**ATTACHMENT B**  
**PROPOSED CHANGES TO APPENDIX A**  
**TECHNICAL SPECIFICATIONS**

- DPR-19 and DPR-25 (Dresden Units 2 and 3)
  - Page B3/4.6-26

- DPR-29 (Quad Cities Unit 1)
  - Page 3.6/4.6-16
  - Page 3.6/4.6-17

- DPR-30 (Quad Cities Unit 2)
  - Page 3.6/4.6-8
  - Page 3.6/4.6-9

**FIGURE 3.6.1**

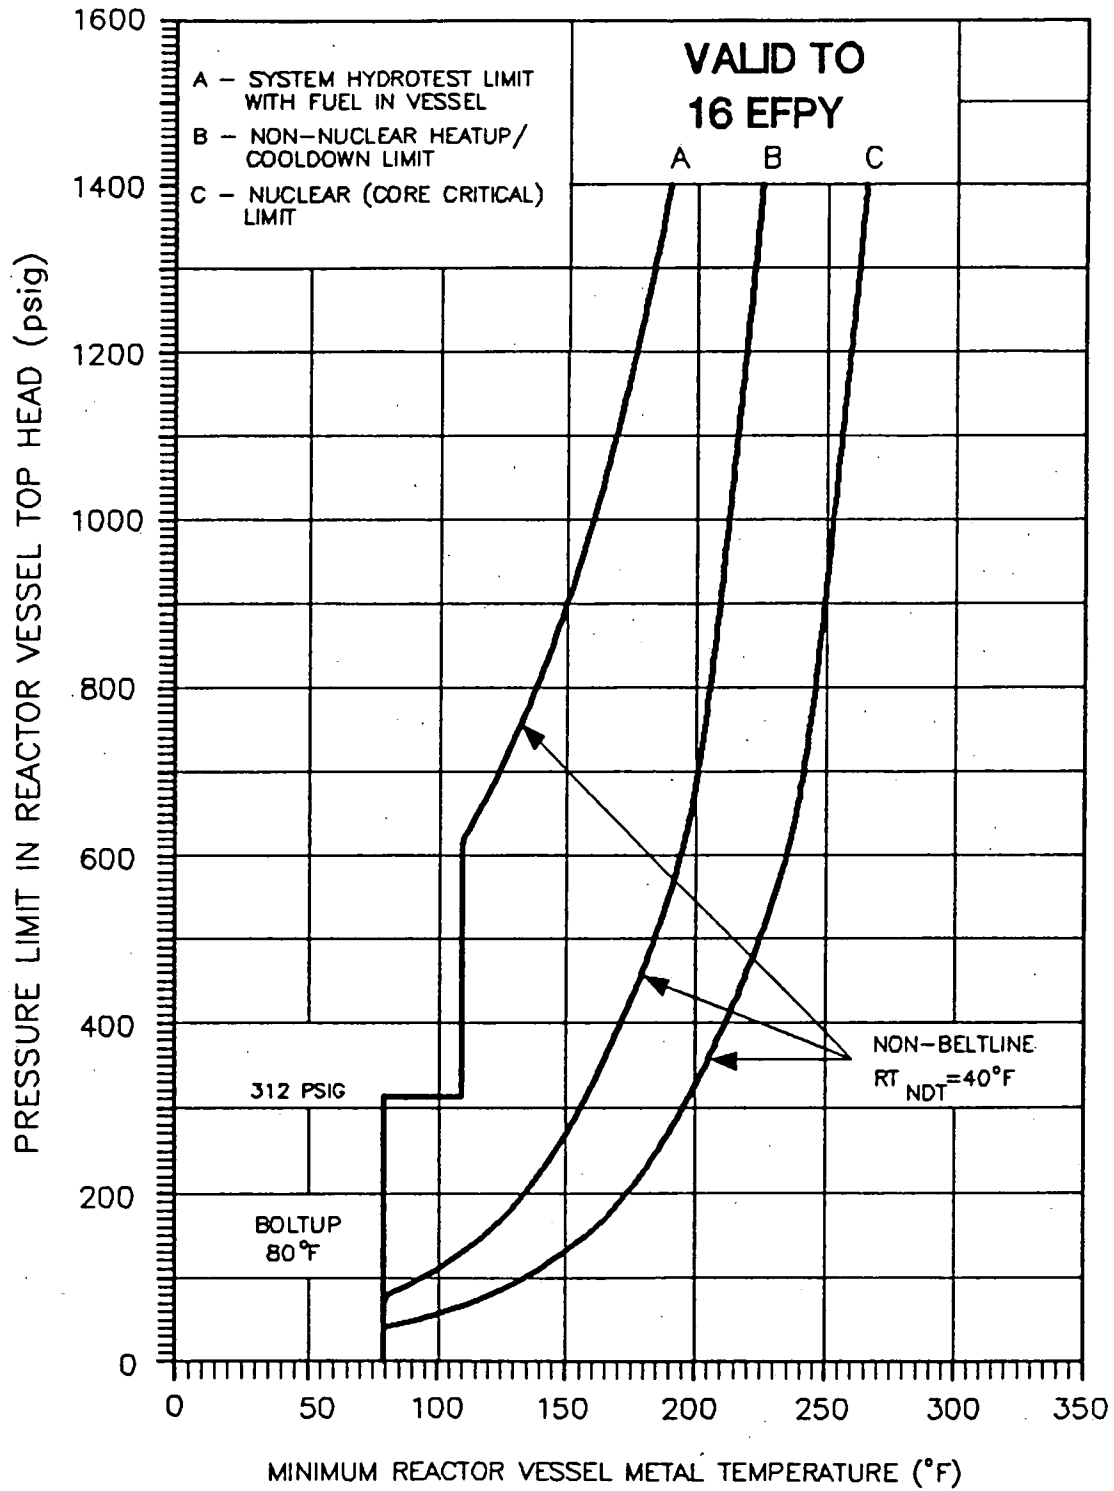
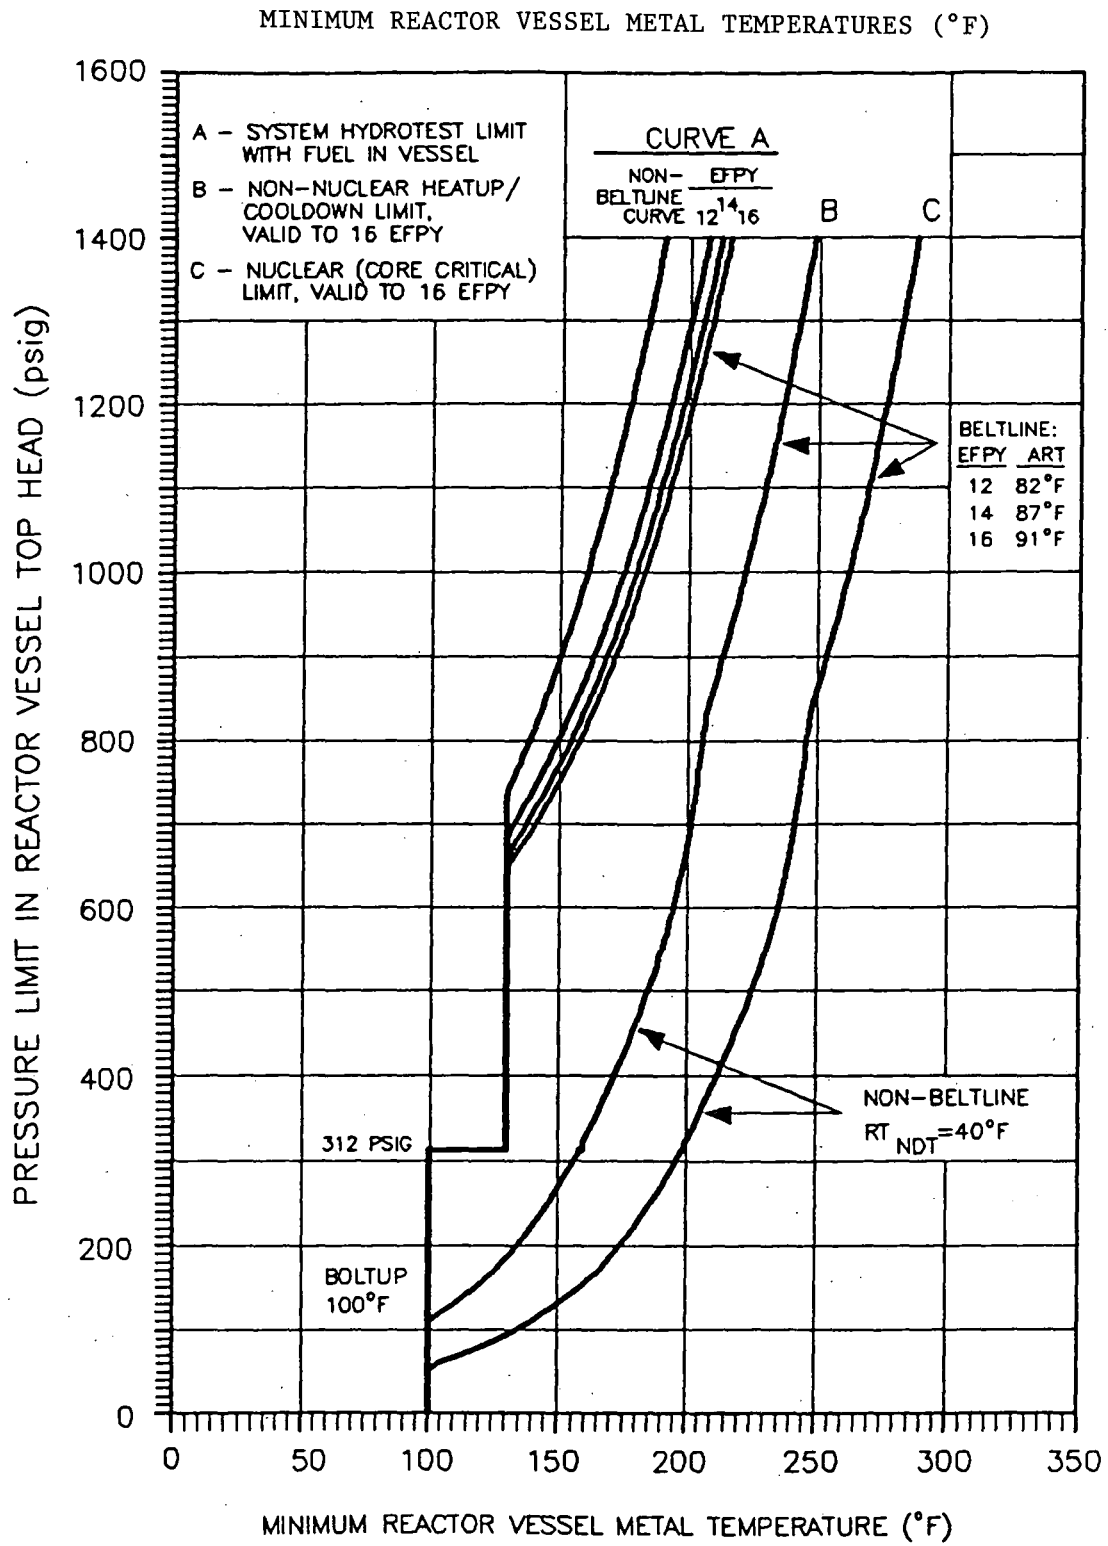
- B. Pressurization Temperature - The reactor vessel is a primary barrier against the release of fission products to the environs. In order to provide assurance that this barrier is maintained at a high degree of integrity, pressure-temperature limits have been established for the operating conditions to which the reactor vessel can be subjected. Figure 3.6.1 presents the pressure-temperature curves for those operating conditions; Inservice Hydrostatic Testing (Curve A), Non-Nuclear Heatup/Cooldown (Curve B), and Core Critical Operation (Curve C). These curves have been established to be in conformance with Appendix G to 10 CFR 50 and Regulatory Guide 1.99, Revision 2, and take into account the change in reference nil-ductility transition temperature ( $RT_{NDT}$ ) as a result of neutron embrittlement. The adjusted reference temperature (ART) of the limiting vessel material is used to account for irradiation effects.

The initial  $RT_{NDT}$  of the main closure flanges, the shell and head materials connecting to these flanges, the connecting welds, and the vertical electroslag welds which terminate immediately below the vessel flange are all 20°F or lower. Therefore, the minimum allowable boltup temperature is established as 80°F ( $RT_{NDT} + 60^\circ\text{F}$ ) which includes a 60°F conservatism required by the original ASME Code of construction.

As indicated in Curve A of Figure 3.6.1 for system hydrotesting, the minimum metal temperature of the reactor vessel shell is 80°F for reactor pressures less than 312 psig. This 80°F minimum boltup temperature is based on a  $RT_{NDT}$  of 20°F for the top head plate (most limiting material) and a 60°F conservatism required by the original ASME Code of construction.

At reactor pressures greater than 312 psig the minimum vessel metal temperature is established as 110°F. The 110°F minimum temperature is based on a closure flange region  $RT_{NDT}$  of 20°F and a 90°F conservatism required by 10 CFR 50 Appendix G for pressure in excess of 20% of the preservice hydrostatic test pressure (1563 psig).

At approximately 620 psig reactor pressure the effects of pressurization become more limiting than the boltup stresses at the closure flange region, as shown by the non-linear portion of Curve A intersecting the vertical 110°F line. The non-linear portion of the curve is dependent on the non-beltline region (which is actually more limiting than the beltline region through a vessel exposure of 22 effective full power years), and based on a  $RT_{NDT}$  of 40°F.

Curve B of Figure 3.6.1 applies during heatups with non-nuclear heat (e.g. recirculation pump heat) and during cooldowns when the reactor is not critical (e.g. following a scram). The curve provides the minimum reactor vessel metal temperatures based on the most limiting vessel stress (non-beltline stresses).

As indicated by the vertical 80°F line, the boltup stresses at the closure flange region are most limiting below approximately 80 psig. Above approximately 80 psig, pressurization and thermal stresses become more limiting than the boltup stresses, which is reflected by the non-linear portion of Curve B. The non-linear portion of the curve is dependent on the non-beltline region (which is actually more limiting than the beltline region through a vessel exposure of 22 effective full power years), and based on a  $RT_{NDT}$  of 40°F.

Curve C, the core critical operation curve shown in Figure 3.6.1, is generated in accordance with 10 CFR 50 Appendix G which requires core critical pressure-temperature limits to be 40°F above any Curve A or B limits. Since Curve B is more limiting, Curve C is Curve B plus 40°F.

- B. Pressurization Temperature - The reactor vessel is a primary barrier against the release of fission products to the environs. In order to provide assurance that this barrier is maintained at a high degree of integrity, pressure-temperature limits have been established for the operating conditions to which the reactor vessel can be subjected. Figure 3.6.1 presents the pressure-temperature curves for those operating conditions; Inservice Hydrostatic Testing (Curve A), Non-Nuclear Heatup/Cooldown (Curve B), and Core Critical Operation (Curve C). These curves have been established to be in conformance with Appendix G to 10 CFR 50 and Regulatory Guide 1.99, Revision 2, and take into account the change in reference nil-ductility transition temperature ( $RT_{NDT}$ ) as a result of neutron embrittlement. The adjusted reference temperature (ART) of the limiting vessel material is used to account for irradiation effects.

The initial  $RT_{NDT}$  of the main closure flanges, the shell and head materials connecting to these flanges, and connecting welds is 10°F; however, the vertical electroslag welds which terminate immediately below the vessel flange have an  $RT_{NDT}$  of 40°F. Therefore, the minimum allowable boltup temperature is established as 100°F ( $RT_{NDT} + 60^\circ\text{F}$ ), which includes a 60°F conservatism required by the original ASME Code of construction.

As indicated in Curve A of Figure 3.6.1 for system hydrotesting, the minimum metal temperature of the reactor vessel shell is 100°F for reactor pressures less than 312 psig. This 100°F minimum boltup temperature is based on a  $RT_{NDT}$  of 40°F for the electroslag weld immediately below the vessel flange and a 60°F conservatism required by the original ASME Code of construction.

At reactor pressures greater than 312 psig the minimum vessel metal temperature is established as 130°F. The 130°F minimum temperature is based on a closure flange region  $RT_{NDT}$  of 40°F and a 90°F conservatism required by 10 CFR 50 Appendix G for pressure in excess of 20% of the preservice hydrostatic test pressure (1563 psig).

At approximately 650 psig the effects of pressurization are more limiting than the boltup stresses at the closure flange region, hence a family of non-linear curves intersect the 130°F vertical line. Beltline as well as non-beltline curves have been provided to allow separate monitoring of the two regions. Beltline curves as a function of vessel exposure for 12, 14 and 16 effective full power years (EFPY) are presented to allow the use of the appropriate curve up to 16 EFPY of operation.

Curve B of Figure 3.6.1 applies during heatups with non-nuclear heat (e.g., recirculation pump heat) and during cooldowns when the reactor is not critical (e.g., following a scram). The curve provides the minimum reactor vessel metal temperatures based on the most limiting vessel stress.

As indicated by the vertical 100°F line, the boltup stresses at the closure flange region are most limiting for reactor pressures below approximately 110 psig. For reactor pressures greater than approximately 110 psig, pressurization and thermal stresses become more limiting than the boltup stresses, which is reflected by the non-linear portion of Curve B. The non-linear portion of the curve is dependent on non-beltline and beltline regions, with the beltline region temperature limits having been adjusted to account for vessel irradiation (up to a vessel exposure of 16 EFPY). The non-beltline region is limiting between approximately 110 psig and 830 psig. Above approximately 830 psig, the beltline region becomes limiting.

Curve C, the core critical operation curve shown in Figure 3.6.1, is generated in accordance with 10 CFR 50 Appendix G which requires core critical pressure-temperature limits to be 40°F above any Curve A or B limits. Since Curve B is more limiting, Curve C is Curve B plus 40°F.

**FIGURE 3.6-1**

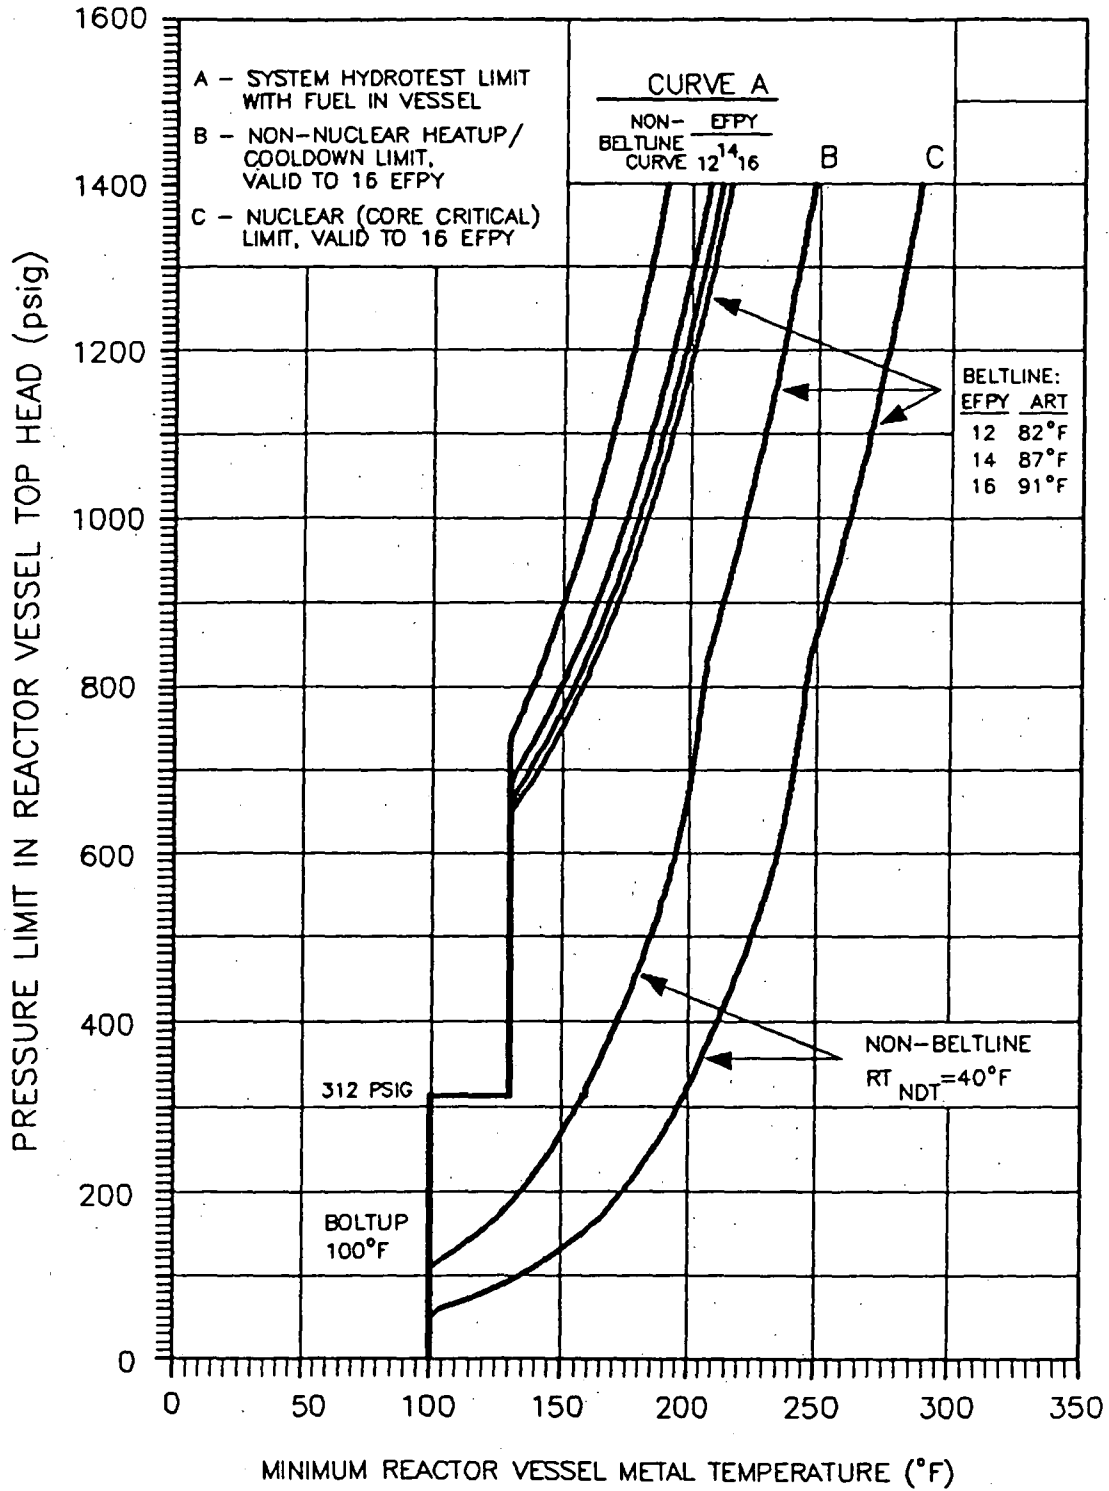
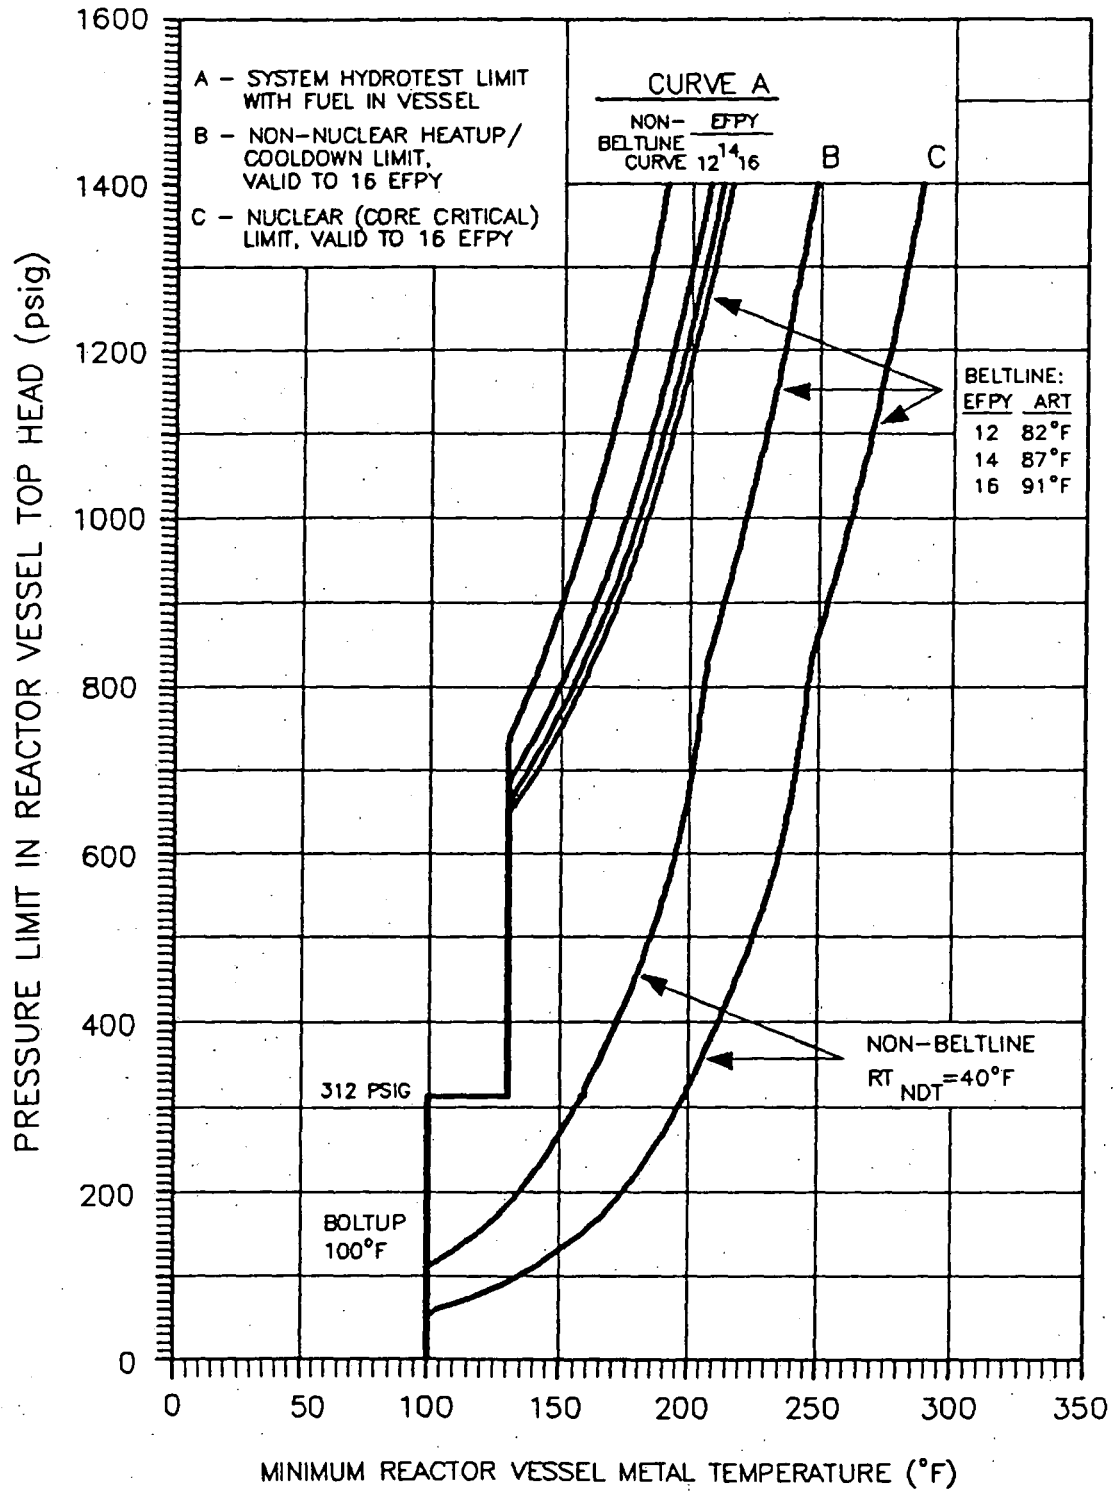
The reactor vessel is a primary barrier against the release of fission products to the environs. In order to provide assurance that this barrier is maintained at a high degree of integrity, pressure-temperature limits have been established for the operating conditions to which the reactor vessel can be subjected. Figure 3.6-1 presents the pressure-temperature curves for those operating conditions; Inservice Hydrostatic Testing (Curve A), Non-Nuclear Heatup/Cooldown (Curve B), and Core Critical Operation (Curve C). These curves have been established to be in conformance with Appendix G to 10 CFR 50 and Regulatory Guide 1.99, Revision 2, and take into account the change in reference nil-ductility transition temperature ( $RT_{NDT}$ ) as a result of neutron embrittlement. The adjusted reference temperature (ART) of the limiting vessel material is used to account for irradiation effects.

The initial  $RT_{NDT}$  of the main closure flanges, the shell and head materials connecting to these flanges, and connecting welds is 10°F; however, the vertical electroslag welds which terminate immediately below the vessel flange have an  $RT_{NDT}$  of 40°F. Therefore, the minimum allowable boltup temperature is established as 100°F ( $RT_{NDT} + 60^\circ\text{F}$ ), which includes a 60°F conservatism required by the original ASME Code of construction.

As indicated in Curve A of Figure 3.6-1 for system hydrotesting, the minimum metal temperature of the reactor vessel shell is 100°F for reactor pressures less than 312 psig. This 100°F minimum boltup temperature is based on a  $RT_{NDT}$  of 40°F for the electrosag weld immediately below the vessel flange and a 60°F conservatism required by the original ASME Code of construction.

At reactor pressures greater than 312 psig the minimum vessel metal temperature is established as 130°F. The 130°F minimum temperature is based on a closure flange region  $RT_{NDT}$  of 40°F and a 90°F conservatism required by 10 CFR 50 Appendix G for pressure in excess of 20% of the preservice hydrostatic test pressure (1563 psig).

At approximately 650 psig the effects of pressurization are more limiting than the boltup stresses at the closure flange region, hence a family of non-linear curves intersect the 130°F vertical line. Beltline as well as non-beltline curves have been provided to allow separate monitoring of the two regions. Beltline curves as a function of vessel exposure for 12, 14 and 16 effective full power years (EFPY) are presented to allow the use of the appropriate curve up to 16 EFPY of operation.

Curve B of Figure 3.6-1 applies during heatups with non-nuclear heat (e.g., recirculation pump heat) and during cooldowns when the reactor is not critical (e.g., following a scram). The curve provides the minimum reactor vessel metal temperatures based on the most limiting vessel stress.

As indicated by the vertical 100°F line, the boltup stresses at the closure flange region are most limiting for reactor pressures below approximately 110 psig. For reactor pressures greater than approximately 110 psig, pressurization and thermal stresses become more limiting than the boltup stresses, which is reflected by the non-linear portion of Curve B. The non-linear portion of the curve is dependent on non-beltline and beltline regions, with the beltline region temperature limits having been adjusted to account for vessel irradiation (up to a vessel exposure of 16 EFPY). The non-beltline region is limiting between approximately 110 psig and 830 psig. Above approximately 830 psig, the beltline region becomes limiting.

Curve C, the core critical operation curve shown in Figure 3.6-1, is generated in accordance with 10 CFR 50 Appendix G which requires core critical pressure-temperature limits to be 40°F above any Curve A or B limits. Since Curve B is more limiting, Curve C is Curve B plus 40°F.

The reactor vessel is a primary barrier against the release of fission products to the environs. In order to provide assurance that this barrier is maintained at a high degree of integrity, pressure-temperature limits have been established for the operating conditions to which the reactor vessel can be subjected. Figure 3.6-1 presents the pressure-temperature curves for those operating conditions; Inservice Hydrostatic Testing (Curve A), Non-Nuclear Heatup/Cooldown (Curve B), and Core Critical Operation (Curve C). These curves have been established to be in conformance with Appendix G to 10 CFR 50 and Regulatory Guide 1.99, Revision 2, and take into account the change in reference nil-ductility transition temperature ( $RT_{NDT}$ ) as a result of neutron embrittlement. The adjusted reference temperature (ART) of the limiting vessel material is used to account for irradiation effects.

The initial  $RT_{NDT}$  of the main closure flanges, the shell and head materials connecting to these flanges, and connecting welds is 10°F; however, the vertical electroslag welds which terminate immediately below the vessel flange have an  $RT_{NDT}$  of 40°F. Therefore, the minimum allowable boltup temperature is established as 100°F ( $RT_{NDT} + 60^\circ\text{F}$ ), which includes a 60°F conservatism required by the original ASME Code of construction.

As indicated in Curve A of Figure 3.6-1 for system hydrotesting, the minimum metal temperature of the reactor vessel shell is 100°F for reactor pressures less than 312 psig. This 100°F minimum boltup temperature is based on a  $RT_{NDT}$  of 40°F for the electroslag weld immediately below the vessel flange and a 60°F conservatism required by the original ASME Code of construction.

At reactor pressures greater than 312 psig the minimum vessel metal temperature is established as 130°F. The 130°F minimum temperature is based on a closure flange region  $RT_{NDT}$  of 40°F and a 90°F conservatism required by 10 CFR 50 Appendix G for pressure in excess of 20% of the preservice hydrostatic test pressure (1563 psig).

At approximately 650 psig the effects of pressurization are more limiting than the boltup stresses at the closure flange region, hence a family of non-linear curves intersect the 130°F vertical line. Beltline as well as non-beltline curves have been provided to allow separate monitoring of the two regions. Beltline curves as a function of vessel exposure for 12, 14 and 16 effective full power years (EFPY) are presented to allow the use of the appropriate curve up to 16 EFPY of operation.

Curve B of Figure 3.6-1 applies during heatups with non-nuclear heat (e.g., recirculation pump heat) and during cooldowns when the reactor is not critical (e.g., following a scram). The curve provides the minimum reactor vessel metal temperatures based on the most limiting vessel stress.

As indicated by the vertical 100°F line, the boltup stresses at the closure flange region are most limiting for reactor pressures below approximately 110 psig. For reactor pressures greater than approximately 110 psig, pressurization and thermal stresses become more limiting than the boltup stresses, which is reflected by the non-linear portion of Curve B. The non-linear portion of the curve is dependent on non-beltline and beltline regions, with the beltline region temperature limits having been adjusted to account for vessel irradiation (up to a vessel exposure of 16 EFPY). The non-beltline region is limiting between approximately 110 psig and 830 psig. Above approximately 830 psig, the beltline region becomes limiting.

Curve C, the core critical operation curve shown in Figure 3.6-1, is generated in accordance with 10 CFR 50 Appendix G which requires core critical pressure-temperature limits to be 40°F above any Curve A or B limits. Since Curve B is more limiting, Curve C is Curve B plus 40°F.
